Addendum 01

DOCUMENT 00 91 00

PROJECT: Clermont County Grant Tower Generator Replacements
3020 State Route 125
Bethel, Ohio 45106

PROJECT #: 26044.00

4 ONE LINE DIAGRAM
NOT TO SCALE

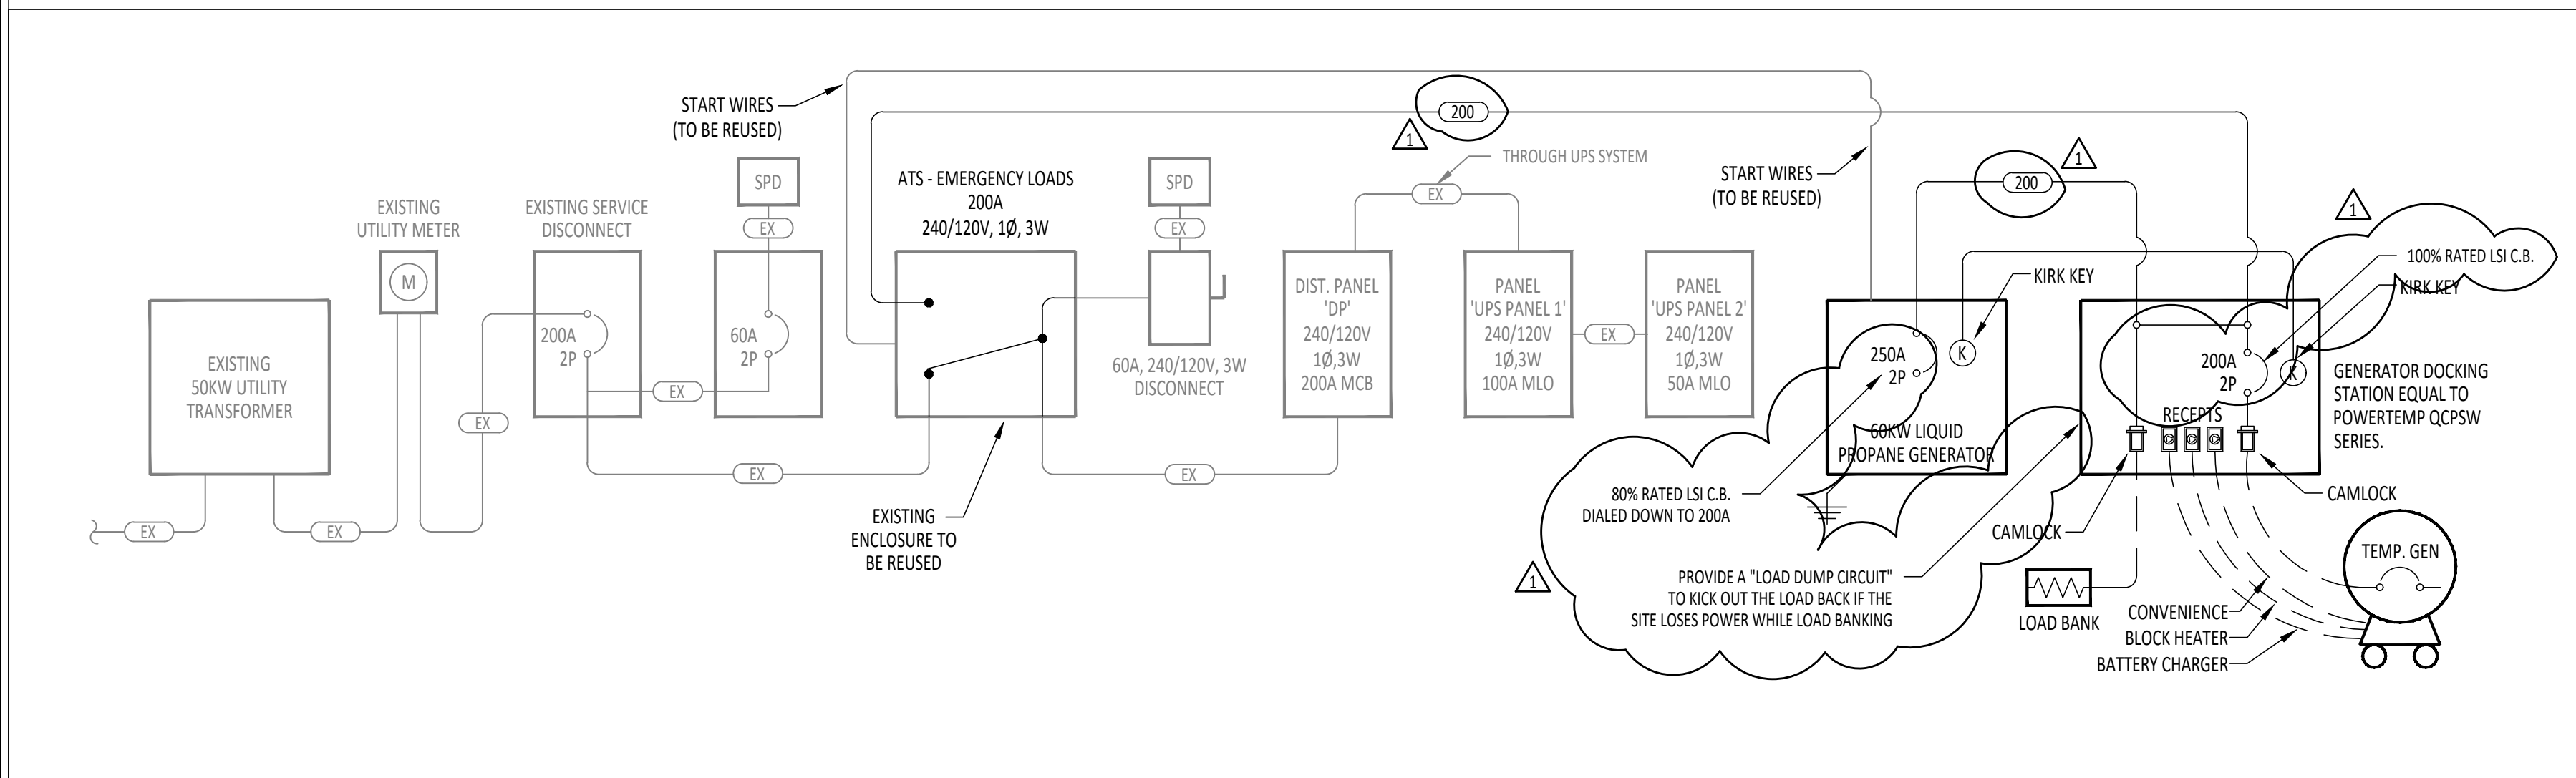
1. Drawing Sheet E1.1 Electrical Plans (reference attached revised sheet):
 - a. Detail 4 One Line Diagram:
 - i. Feeder tags and conductor sizes have been modified for wiring between the docking station and ATS - and docking station and generator.
 - ii. The generator circuit breaker size has been modified.
 - iii. The docking station load bank circuit breaker has been removed.
 - iv. The docking station temporary generator circuit breaker size has been modified.
 - b. Feeder Schedule: The 300-amp tag has been replaced with a 200-amp tag, conductor sizes have been modified in the schedule.
